### Remarks

Entry of this amendment, reconsideration of the application, and allowance of all claims are respectfully requested. Claims 1-31 remain pending.

fig. 1

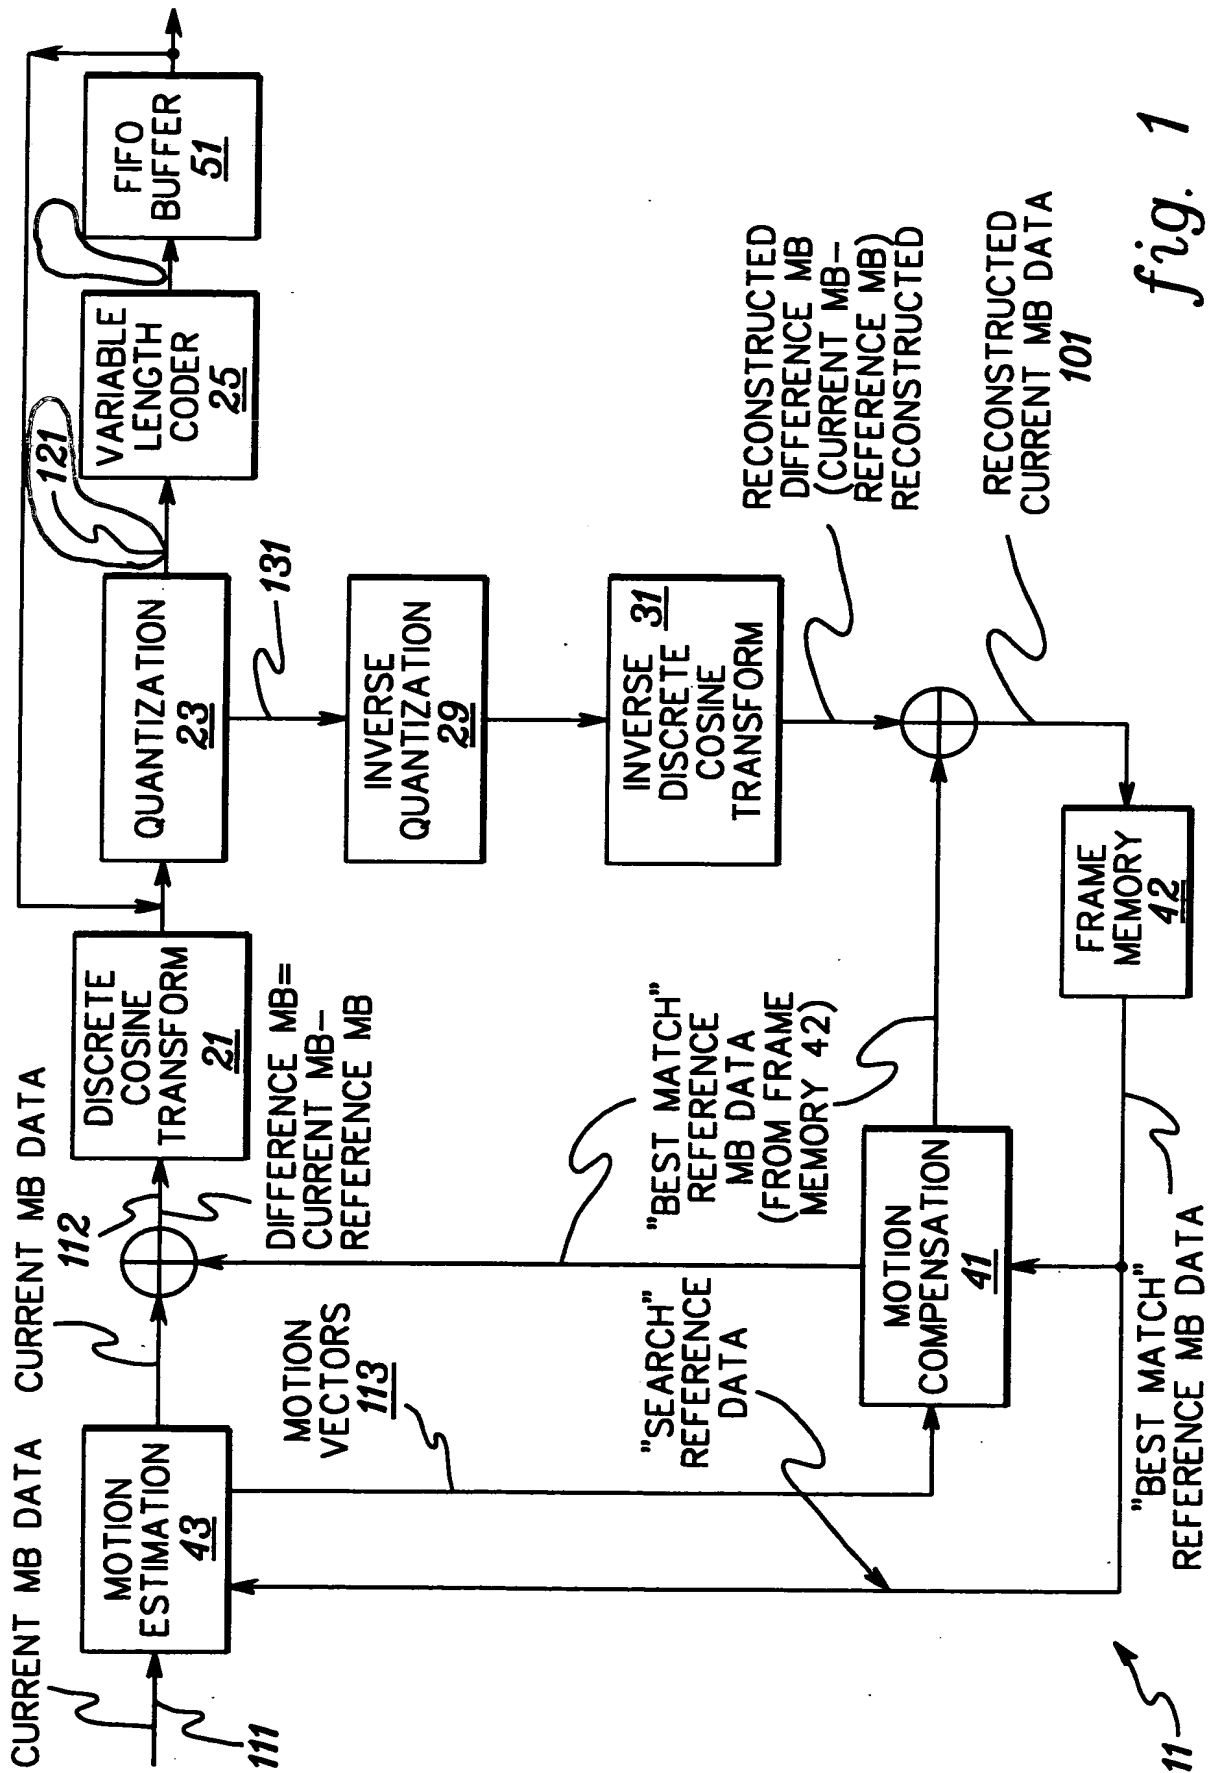
With respect to the objection to FIG. 1, reference "121" has been changed to between block elements 23 and 25 in order to agree with page 9, lines 9-13 of the specification, as suggested by the Examiner. Further, independent claims 1, 9, 16 & 27 are amended to delete "run length encoded" from the reconstruction step recited therein. Based upon this deletion, applicants respectfully request reconsideration and withdrawal of the drawings objection under 37 C.F.R. 1.83(a). As is noted in the Office Action, FIG. 1 of the drawings shows reconstruction of the DCT and quantization data (see elements 29, 31 of FIG. 1).
